Figure 2.1d
Infrastructure Design Review
- Turbine 04

Bhlaraidh Wind Farm Extension
S36C Varied Development

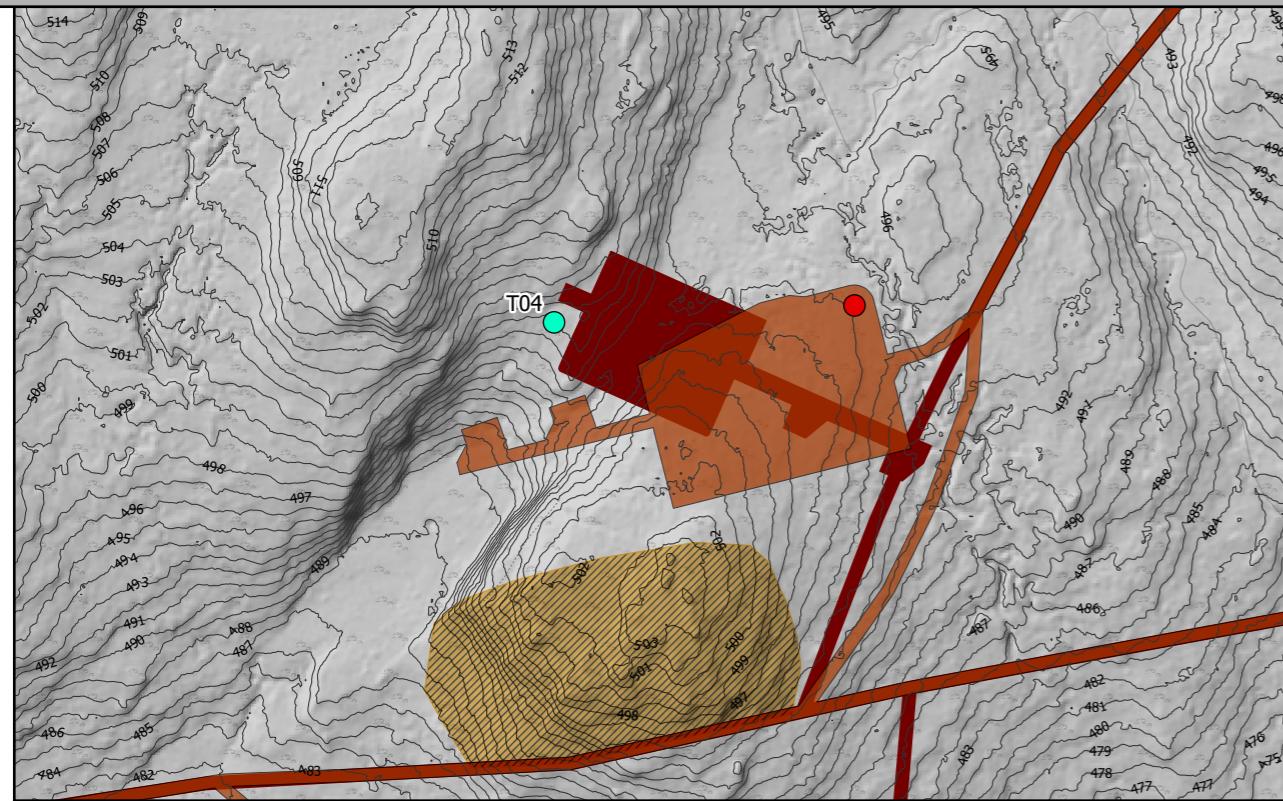
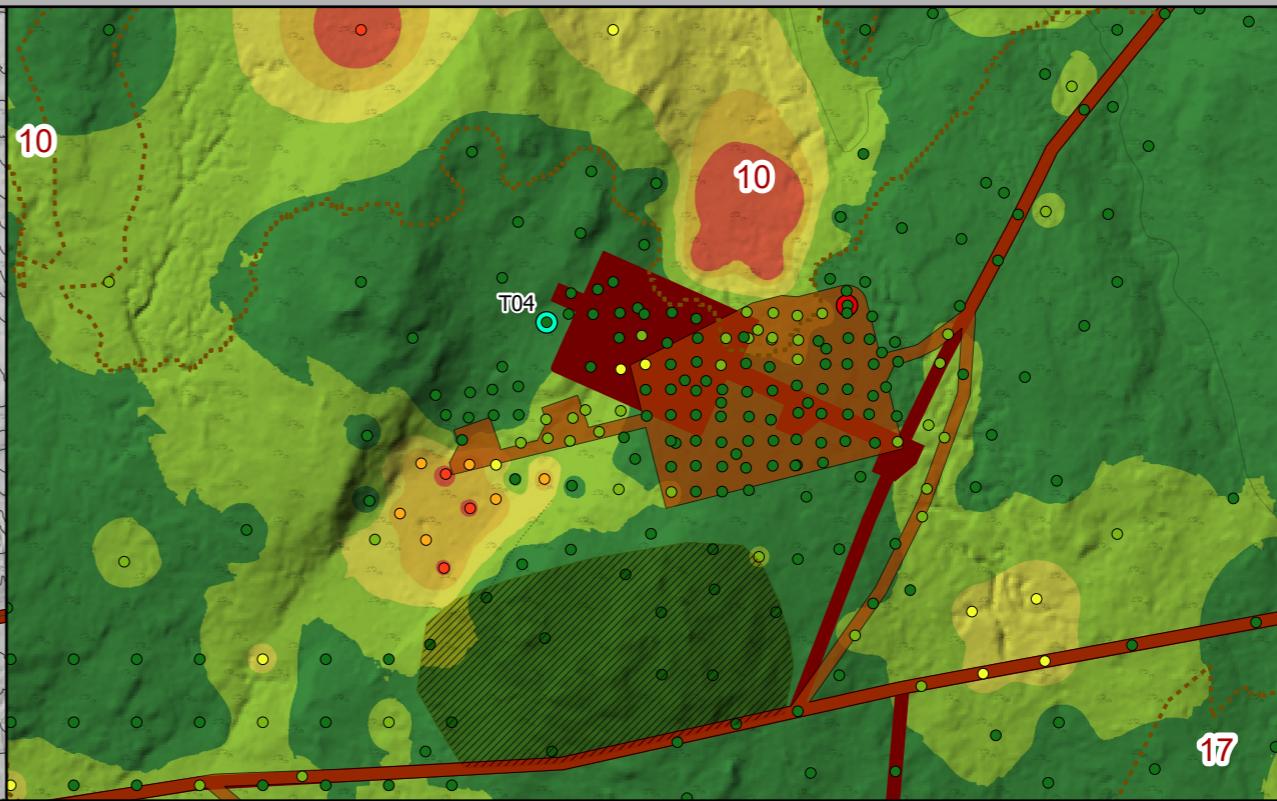
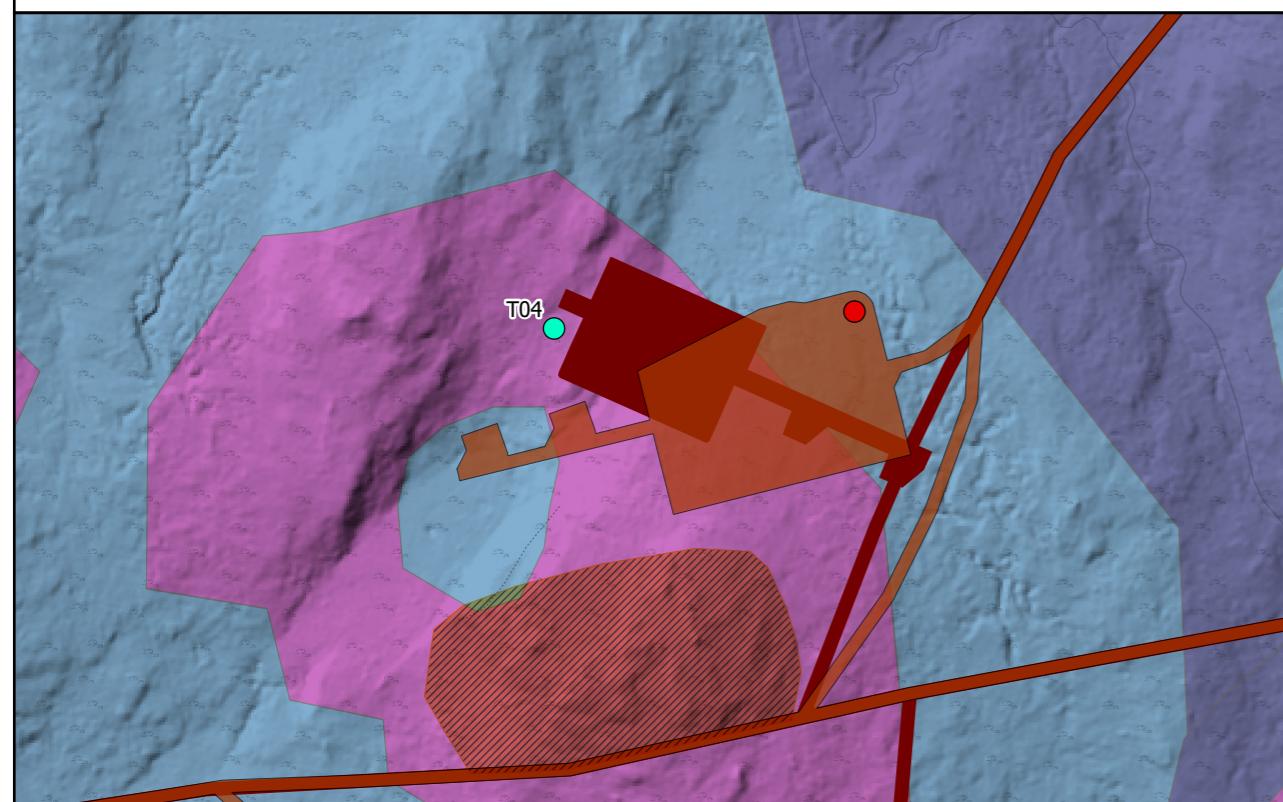
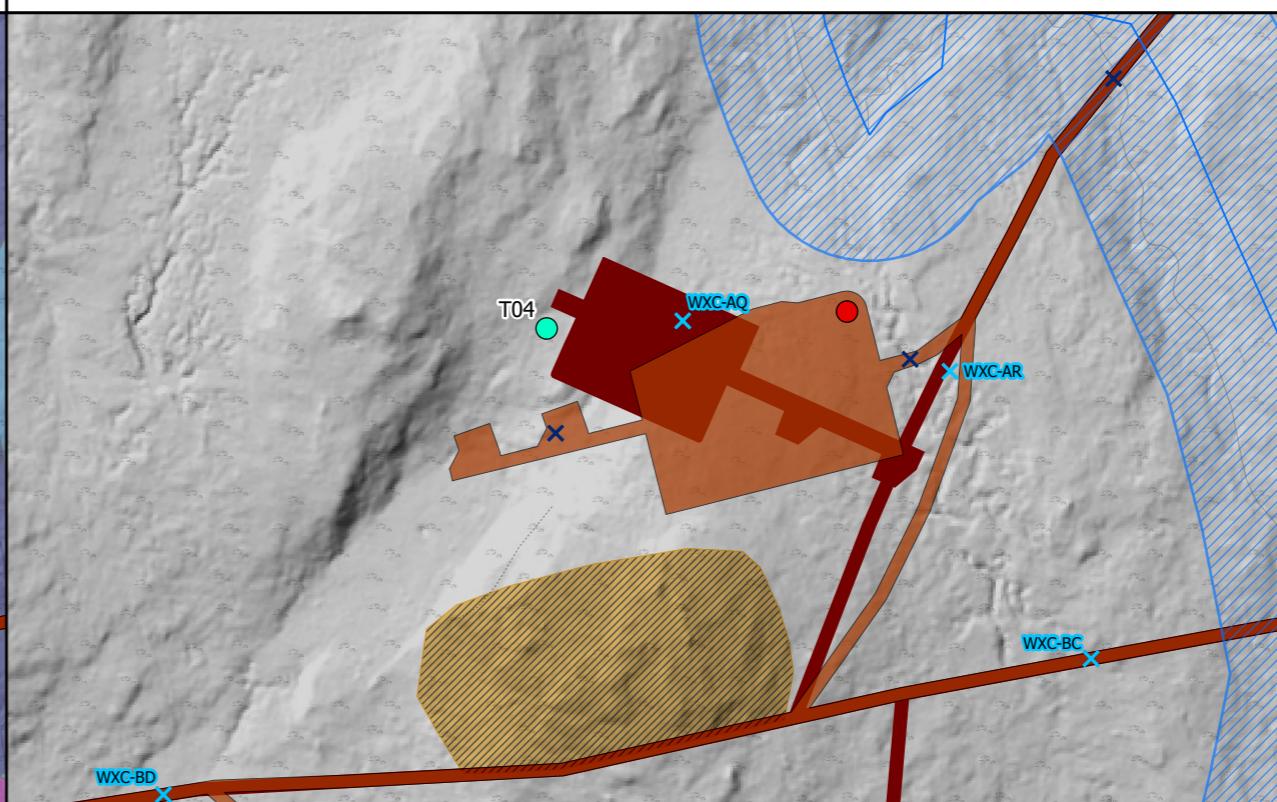
T04: Reason for Moving: This move is necessary to ensure a suitable topple distance between the turbine and the substation platform. Given the turbine's central location within the windfarm layout, the direction of potential movement was limited to avoid negatively impacting other turbines.

Engineering: The rotation of the hardstand to allow for access from the North-East provides a greater run distance from the Spine Road and thus reducing the gradient of the Spur Road to acceptable levels. The new arrangement also avoids overlap between the temporary crane pads and the access track.

Geology Impacts: The consented location could not accommodate the larger hardstands required for the proposed turbine technology. The selected location necessitates a reverse manoeuvre to deliver components to the hardstand, with delivery vehicles using the unloaded turning head at T05 to exit the site. The proposed infrastructure is almost entirely within the current consented 50m micrositing buffer for tracks and hardstands, with peat depths similar to those of the consented layout.

Ecology Impacts: The consented hardstand is too small for the installation of the turbines being considered for the project. Increasing the hardstand would introduce areas of vegetation from the consented Wet Heath (M15c) and Blanket Mire (M17b, M17/M17a/M18a/M19a). The new proposed location has a similar effect, impacting the same habitat types.

Hydrology Impacts: The proposed location is outside the 50m water buffers. Similar to the current consented location, a watercourse crossing is required on the track at the entrance to the hardstand.
